MEMORANDUM

SUBJECT: DRB Meeting of 08-11-09, Item # I-2, 15 Violet Lane

Item # I-2 on your agenda for August 11, 2009 includes Revised Final review of the exterior elevation changes proposed for the single family dwelling at 15 Violet Lane. The DRB granted Final Approval for the existing partially constructed dwelling on December 3, 2002.

EXTERIOR ELEVATION REVISIONS FROM ORIGINAL PERMIT DESIGN

FRONT ELEVATION
Scale: 1/4" = 1'-0"

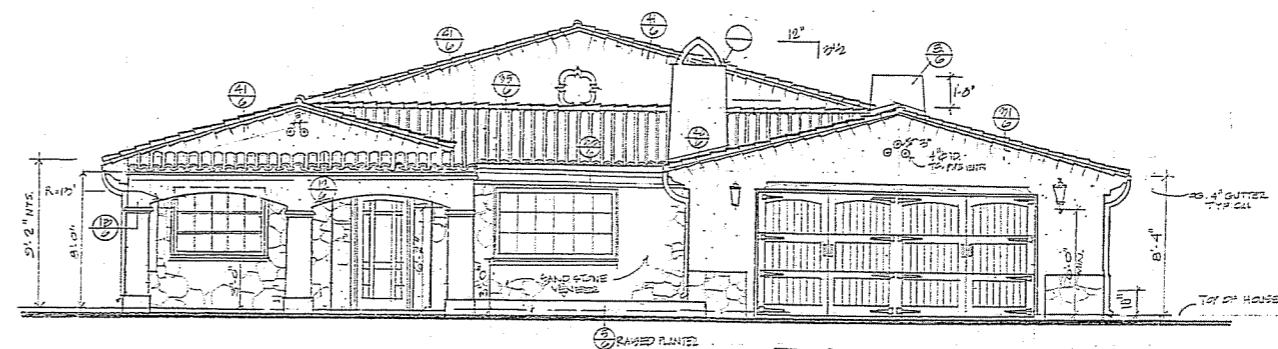
East (Front) Elevation

1. Introduce stone wall finish full height at selected walls this exterior elevation.
2. Garage doors to be carriage style, not "paneled".
3. Relocate Living Room window 20 inches south
4. Pair of doors at Bedroom #4 to be 6 x 4 fixed window
5. Vent at upper gable at west of Atrium to be quatrefoil faux window

LEFT ELEVATION
Scale: 1/4" = 1'-0"

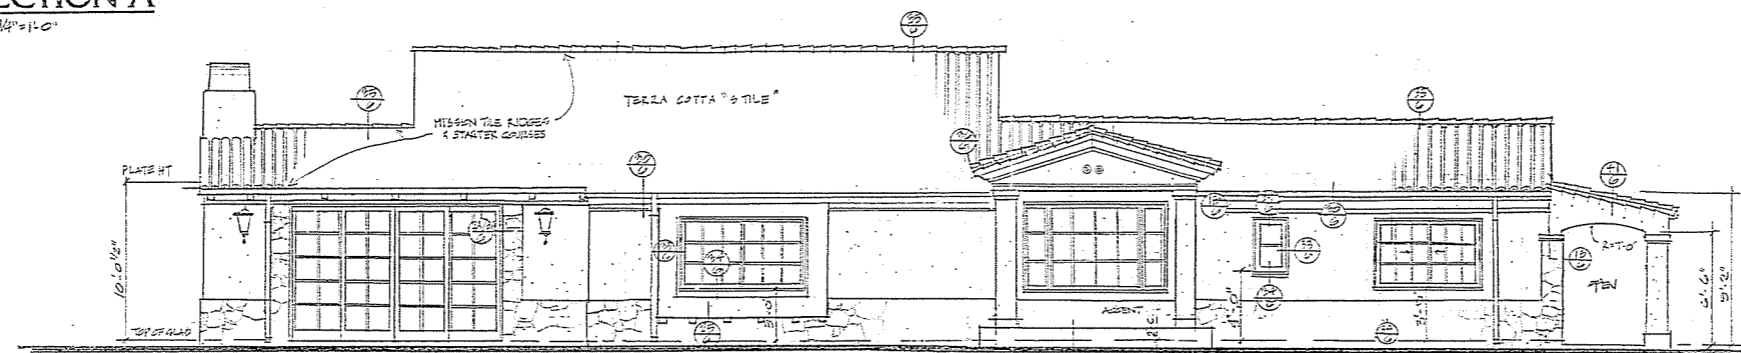
Left Side (South) Elevation :

1. Revise Bedroom #4 Window to have higher sill, allowing stone wainscot full height below.
2. Cut back gable at Dining area, and develop pediment above window height as accord to length of the otherwise east-west eaves.

REAR

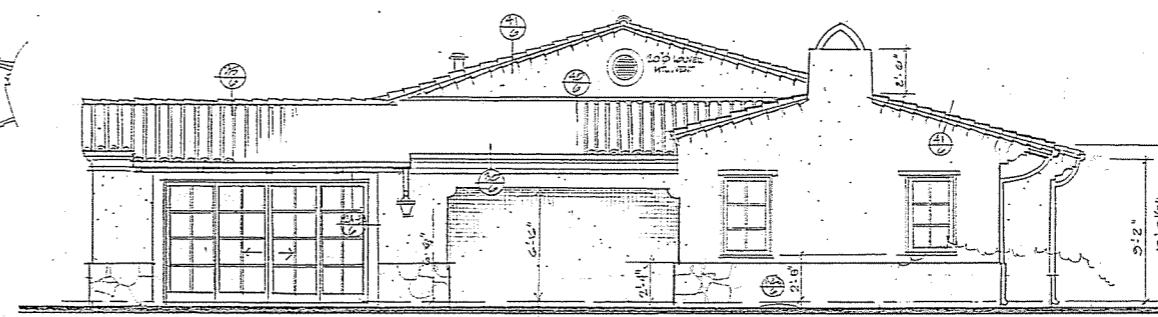
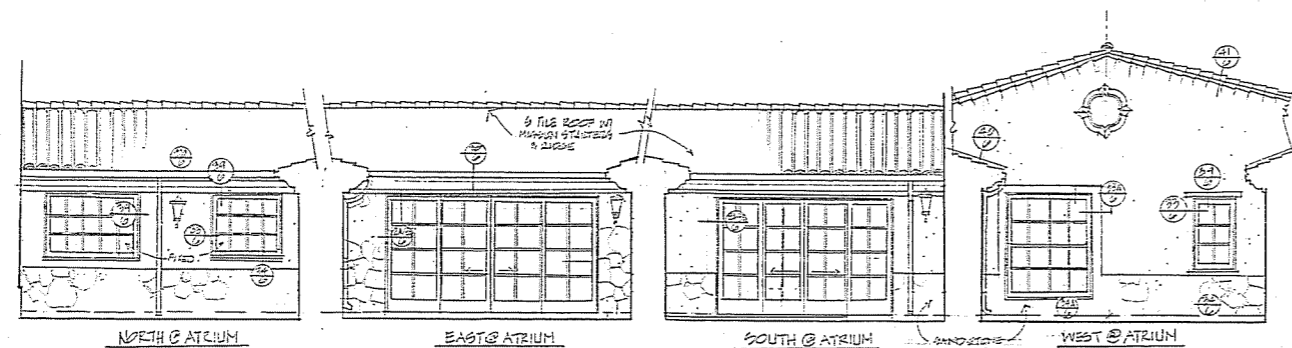
Rear (West) Elevation :

1. Add corbels each side recess at north of Family Room. Provide access color this recess.
2. Windows at Family Room re-sized and relocated
3. Four foot retaining walls added at drainage channel along west property line to allow yard to reduce slope and gain more available use. Low three foot walls added at west of existing retaining walls, north and south property lines to provide needed retention

RIGHT SIDE ELEVATION
Scale: 1/4" = 1'-0"

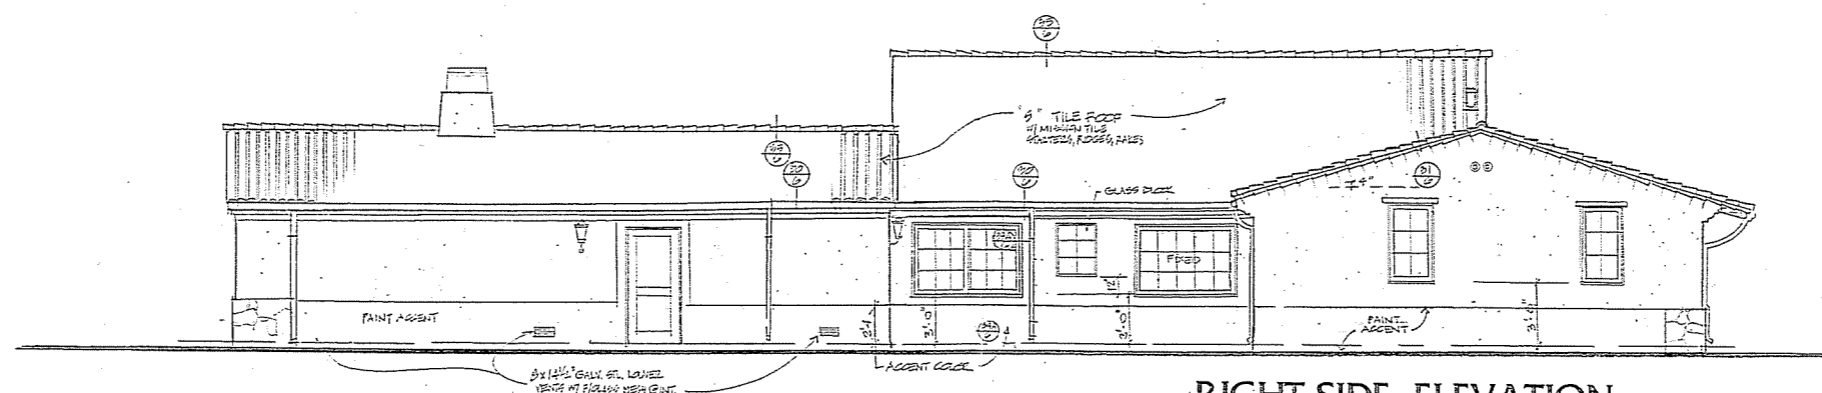
1. Delete sliding glass door and large window at Garage: add solid 3'-0 x 6'-8 door.
2. Revise East window master Bath, and window at Bath #2 to have fixed glass block
3. Delete Projecting seat window at Master Bed, and add two 2'-5 x 5'-0 casement fixed windows
4. Sliding door at Bedroom #3 to become a venting window as shown
5. Wainscot most of this wall a paint "splashband", same height as adjoining stone wainscot.
